DUKE POWER COMPANY  
DESIGN ENGINEERING DEPARTMENT

SQRT AUDIT RESOLUTIONS  
CATAWBA UNIT 1  
FOR  
SQRT AUDIT CONDUCTED  
MARCH 13-16, 1984

RESOLUTION SUBMITTAL DATE  
APRIL 17, 1984

CATAWBA NUCLEAR STATION  
SEISMIC QUALIFICATION OF SAFETY-RELATED ELECTRICAL EQUIPMENT  
RESOLUTION OF SQRT AUDIT ITEMS

VALVE NODES  
FIGURE 1

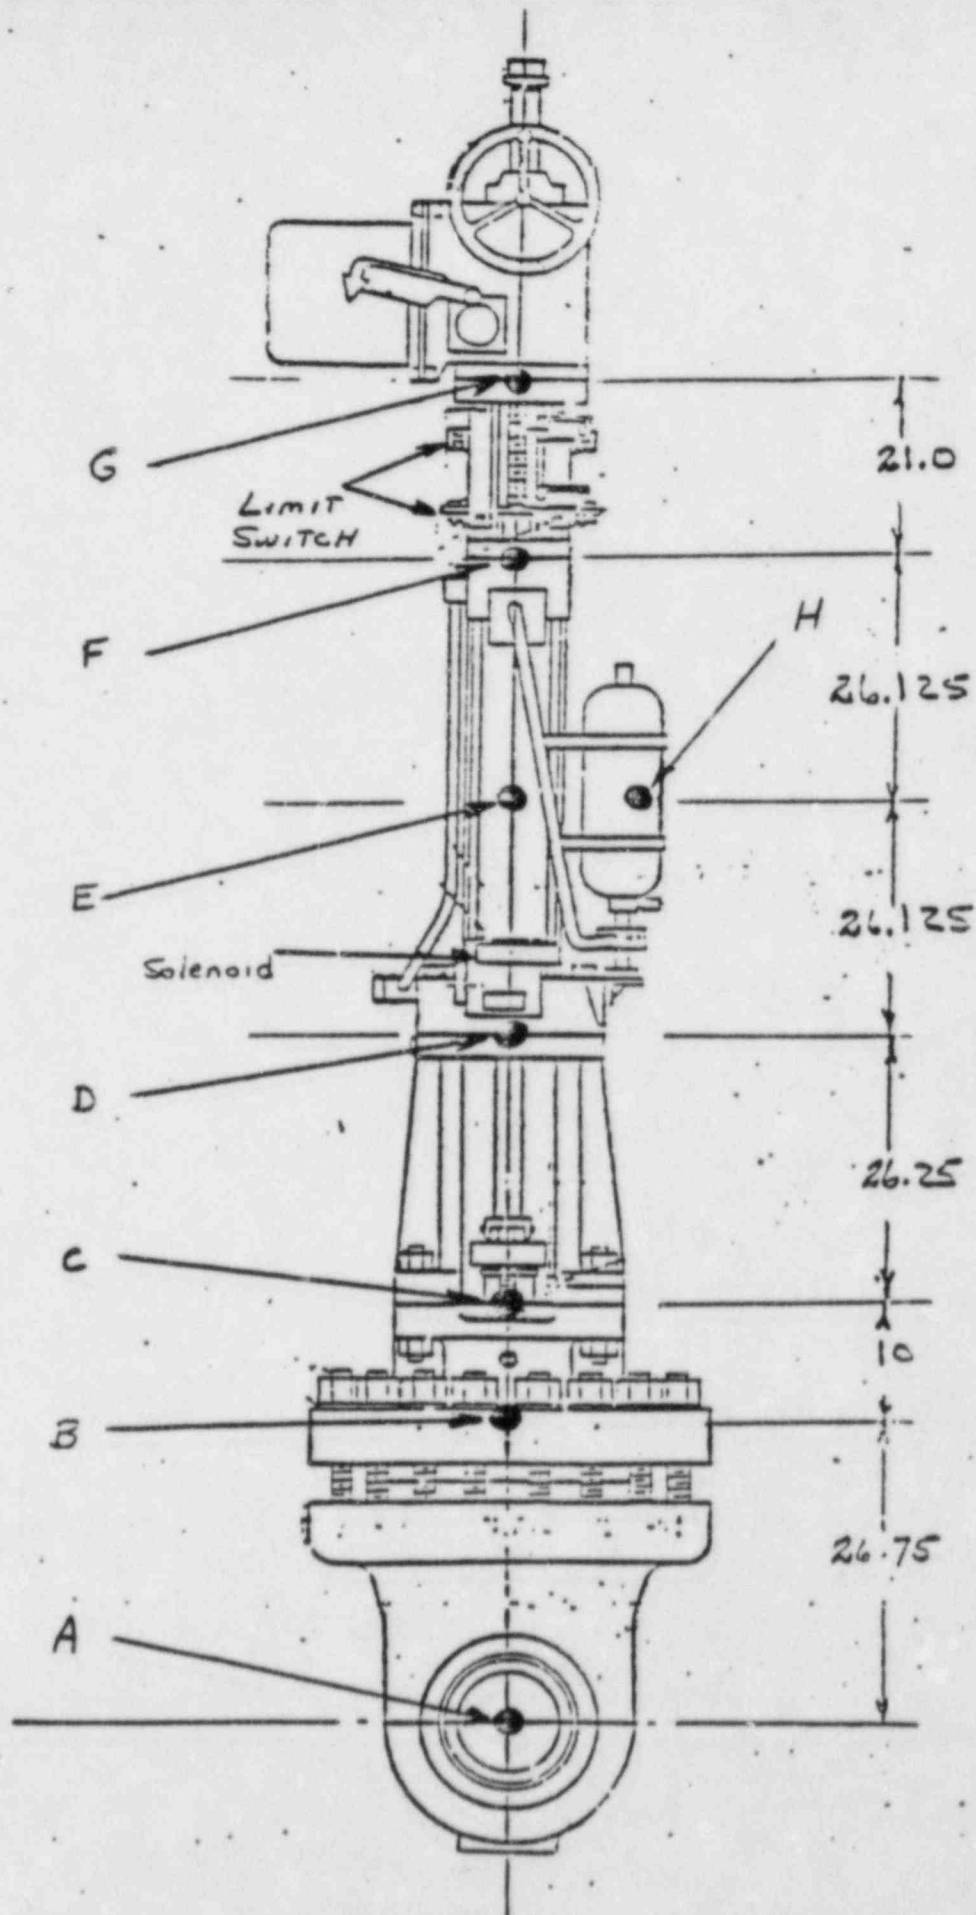
PART 1: SQRT form to be revised in two places.

RESOLUTION SUMMARY: The revised SQRT form follows this page.

The seismic analysis was performed using a horizontal SSE acceleration of  $6.1g$ 's,  $(G_x^2 + G_z^2)^{1/2}$  and a vertical acceleration of  $2.0g$ 's which is greater than the horizontal acceleration of  $6.09g$ 's on all cross-sections on valve 9902B (worst case accelerations) except those listed below. The below sections were analyzed using accelerations which are greater than those at the node points near the center of gravity of the section analyzed.

Figure 1

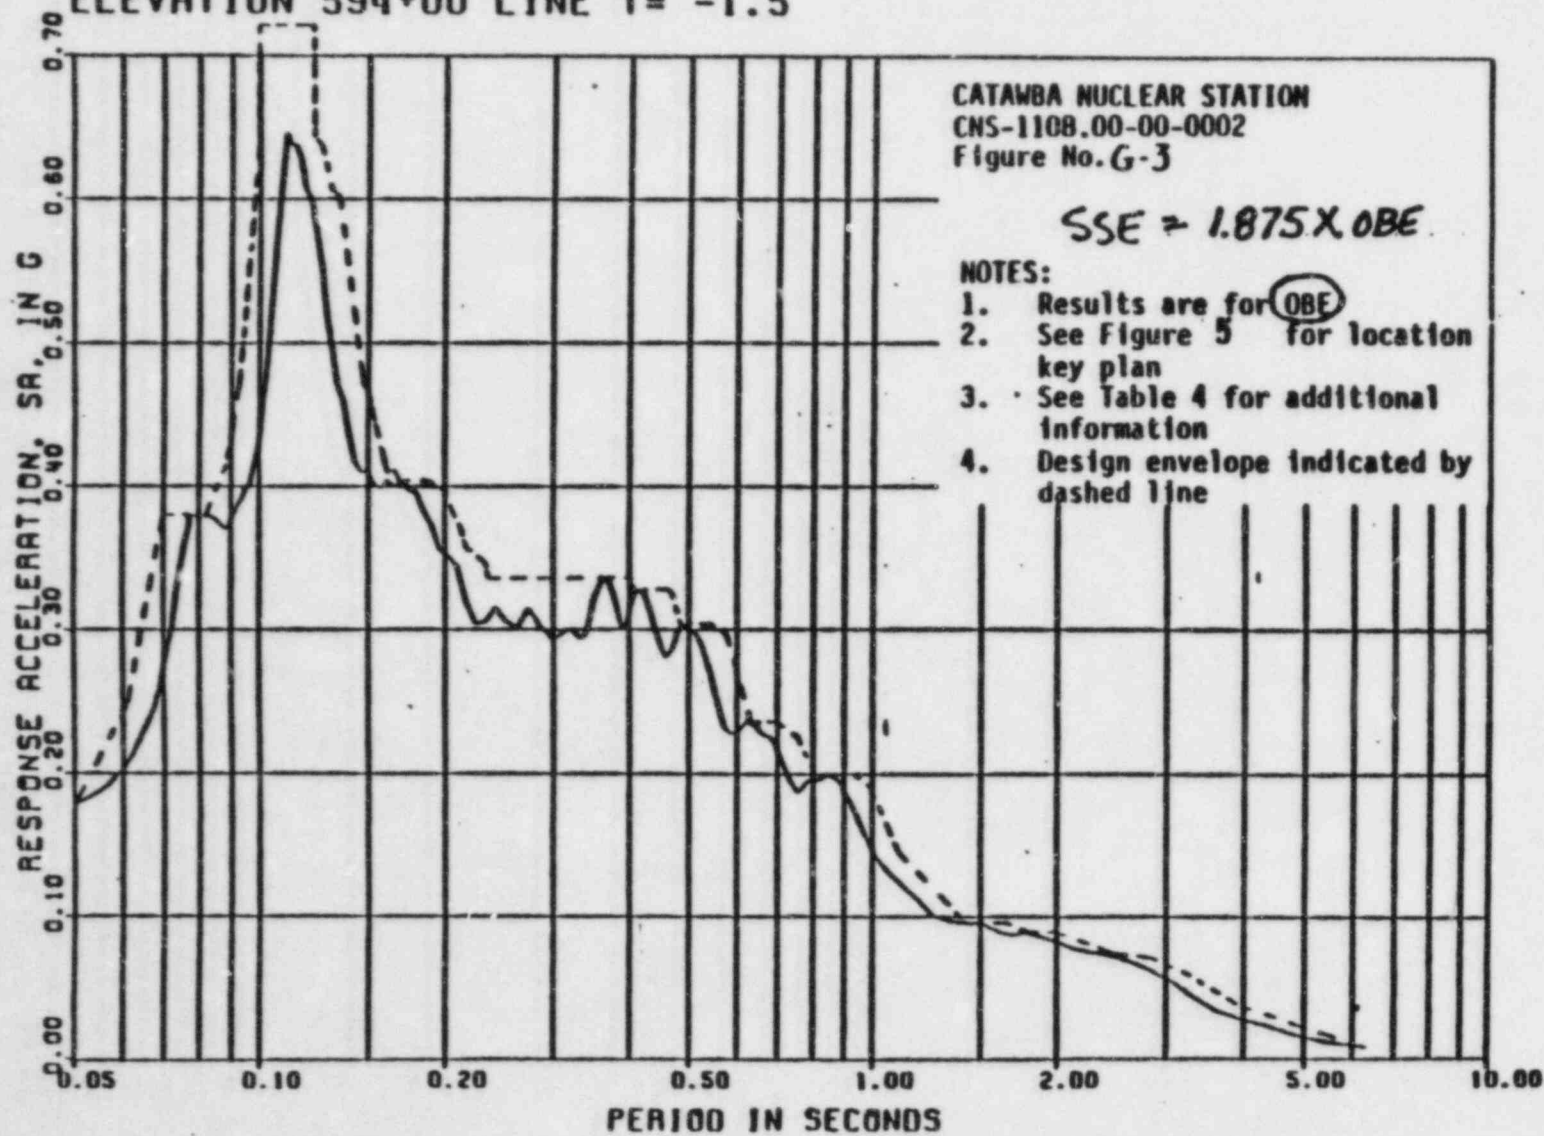
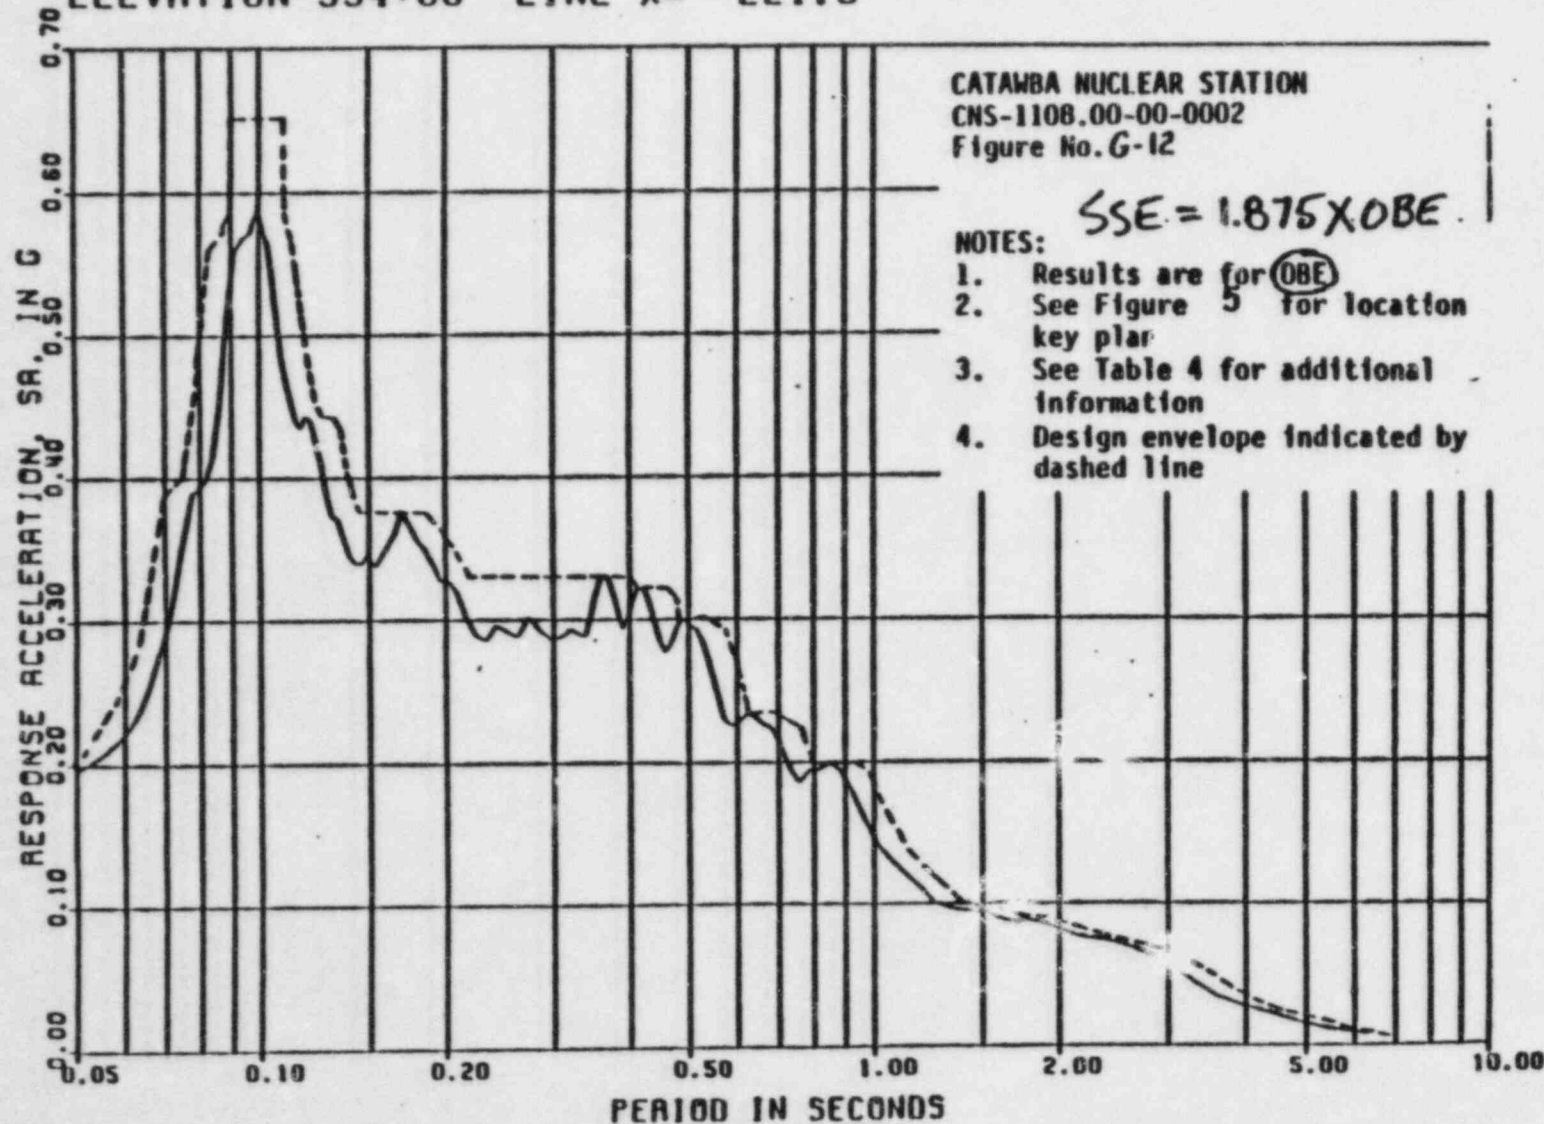
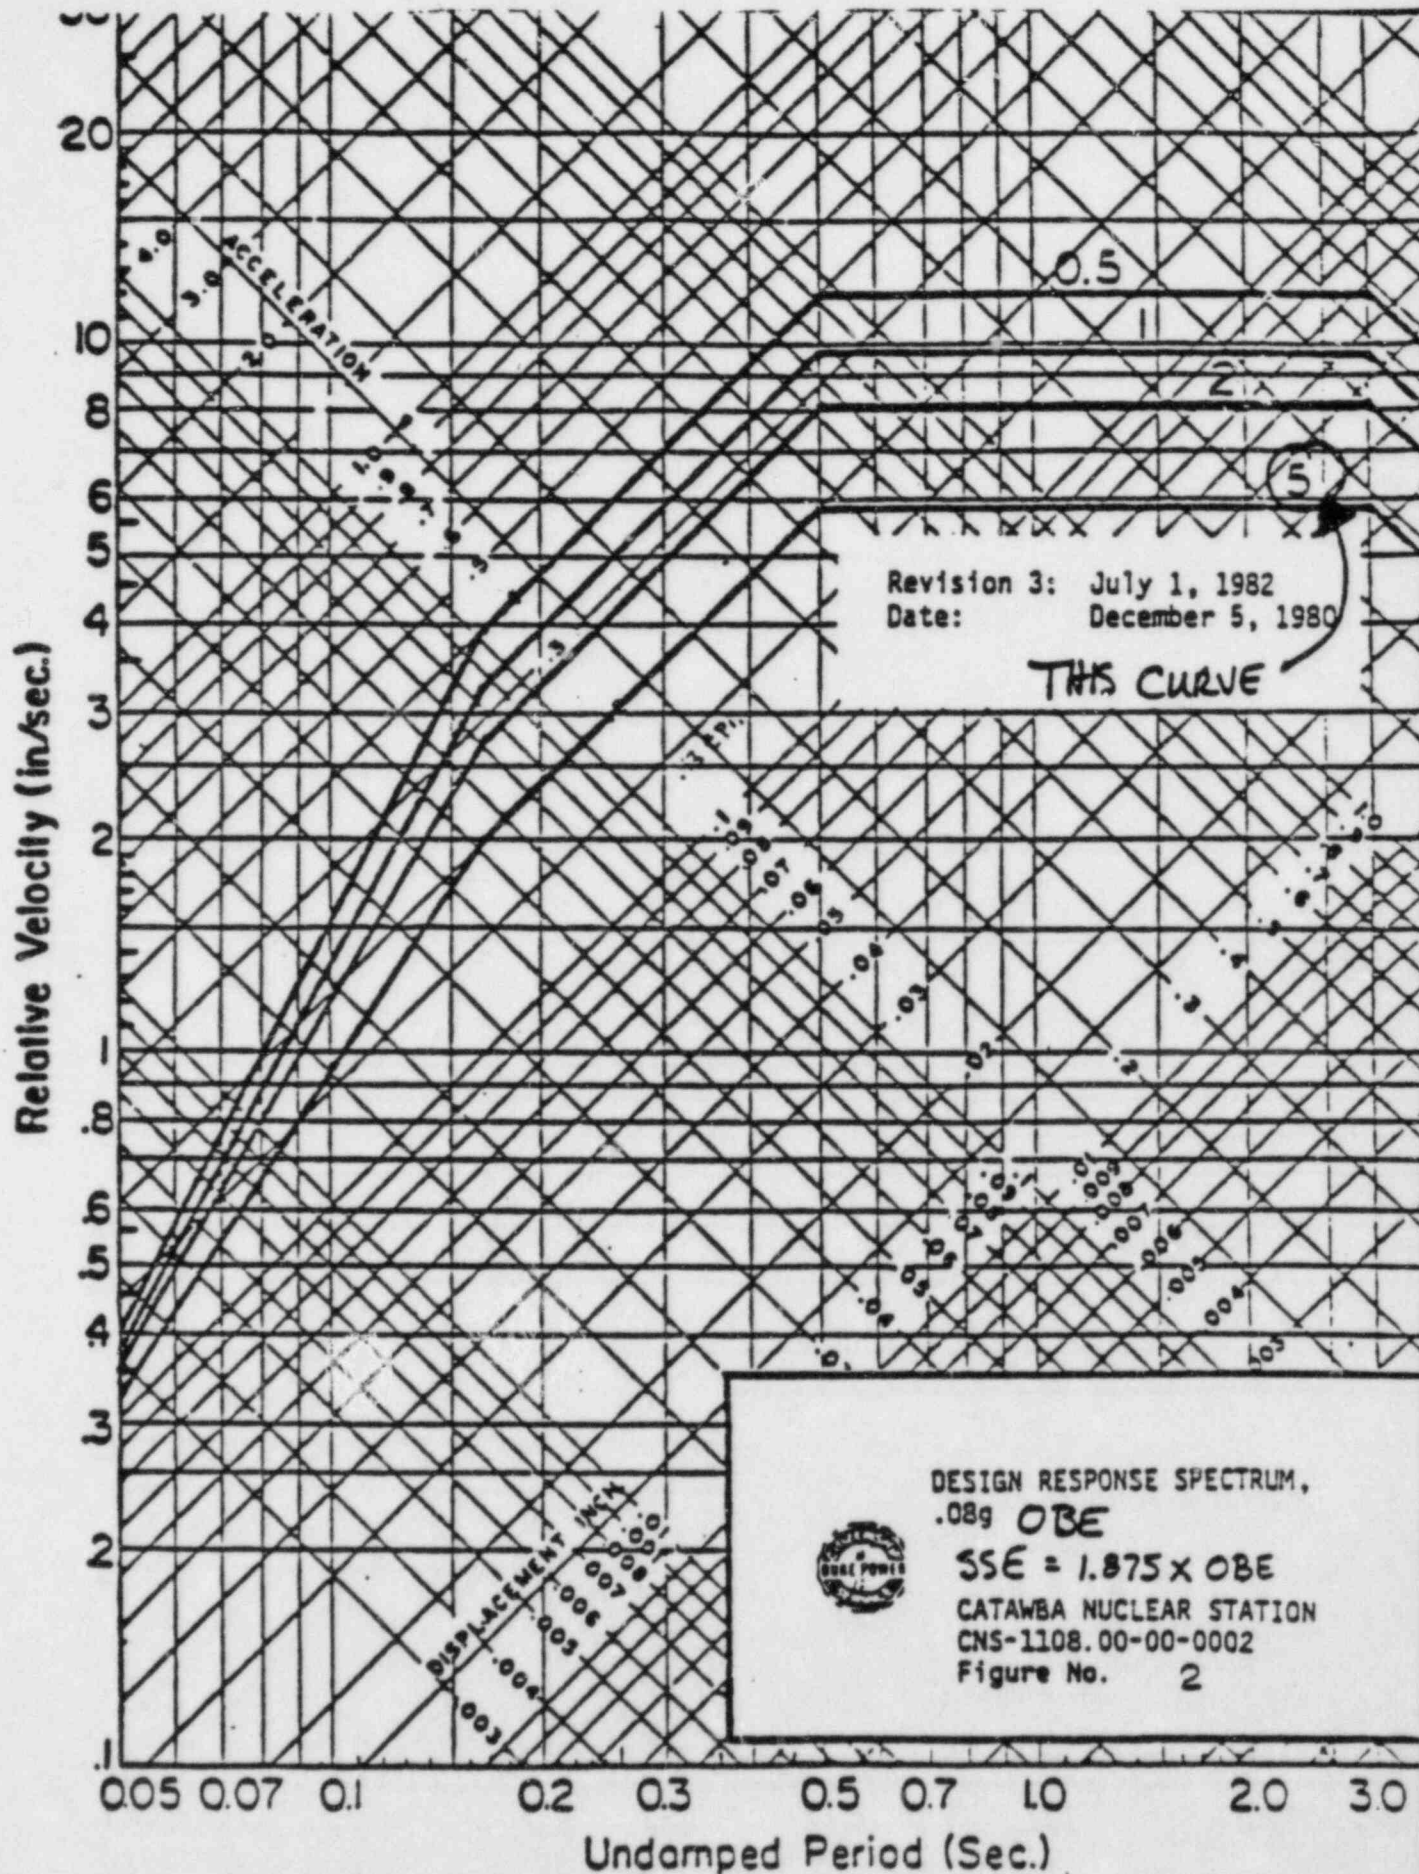
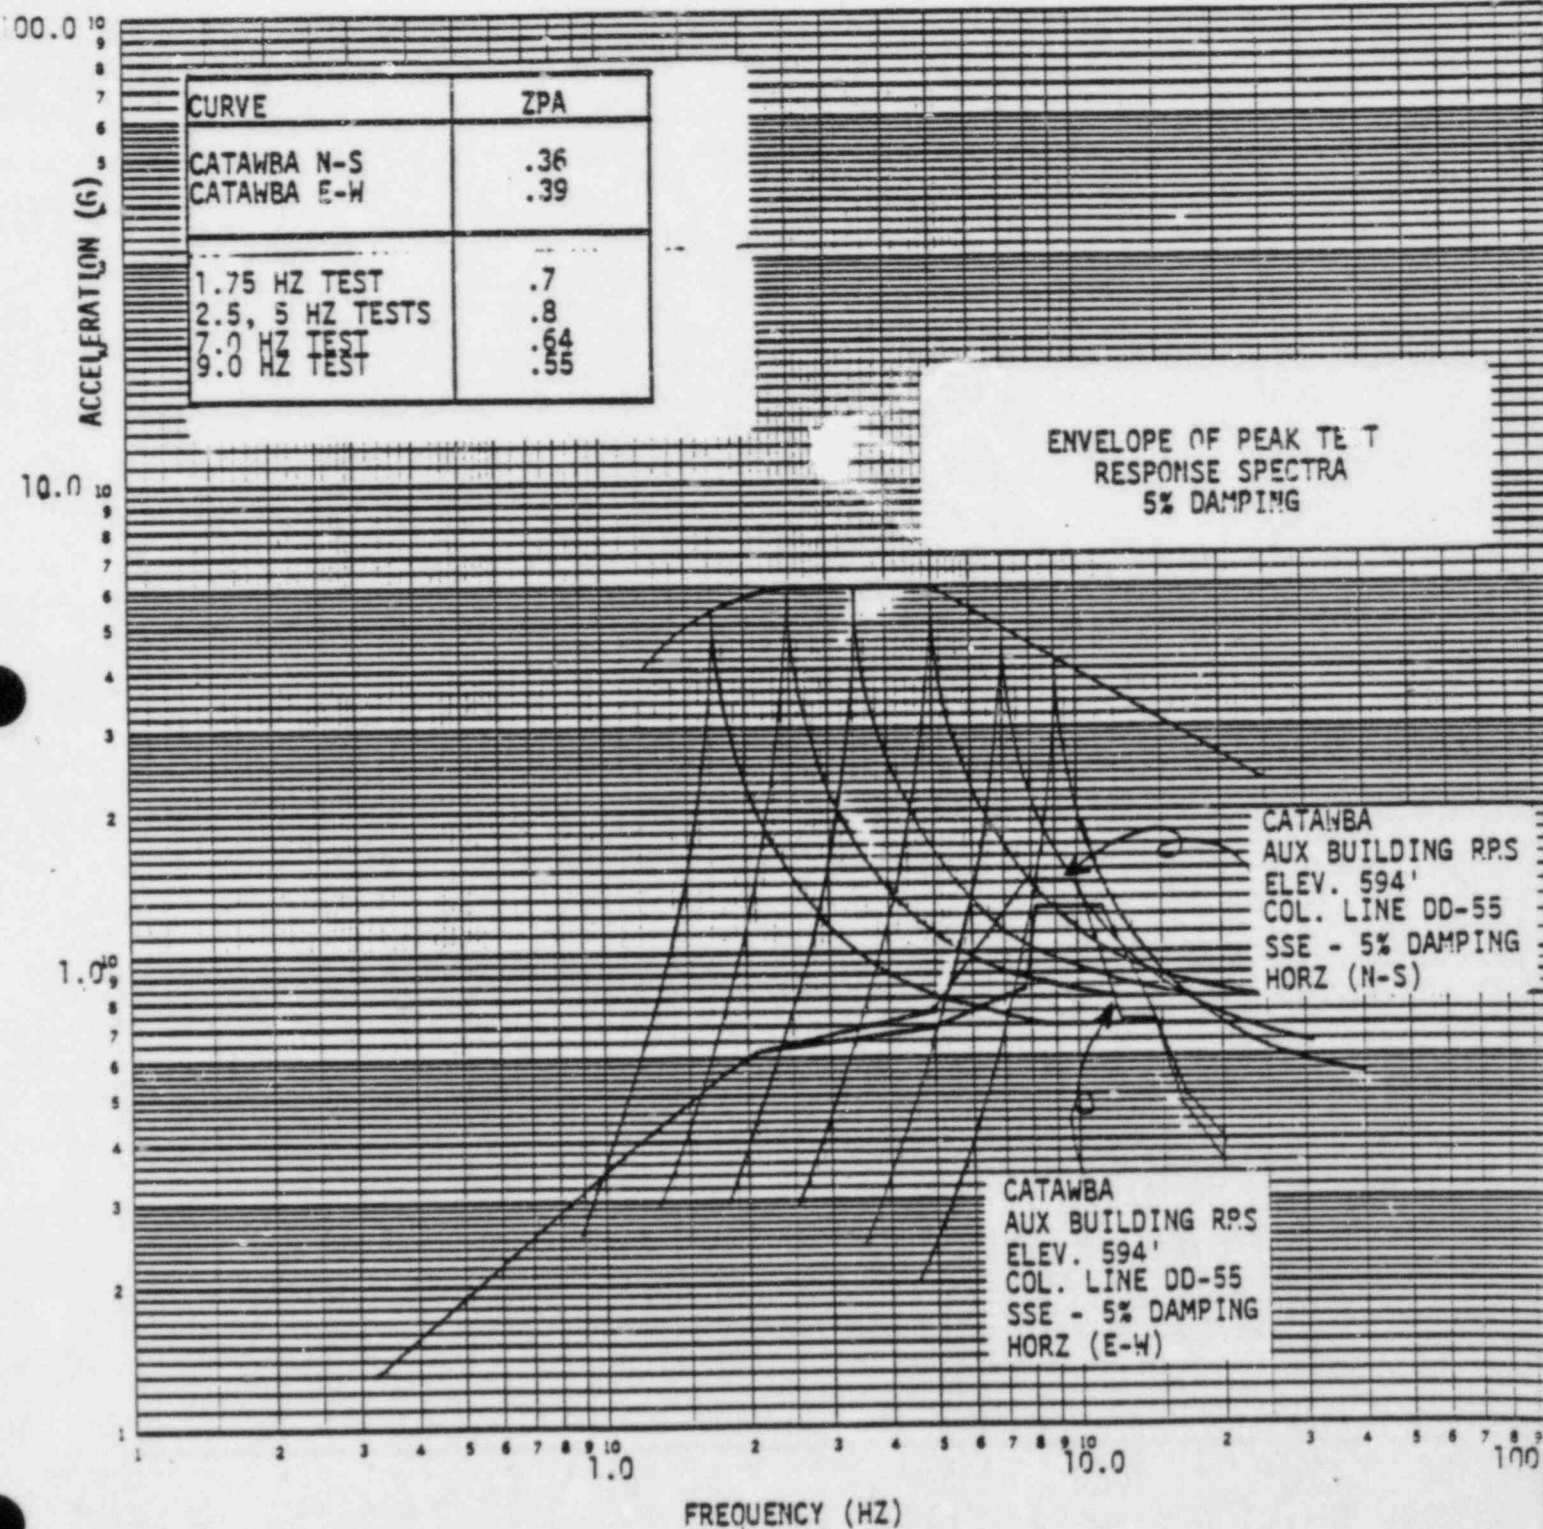
PART 1: Shim is required at bottom of cabinet to provide continuous contact.

RESOLUTION SUMMARY: The Unit 1 Engineering Safeguards Test Cabinet will be inspected and, if necessary, shims will be installed to provide continuous contact prior to fuel load.
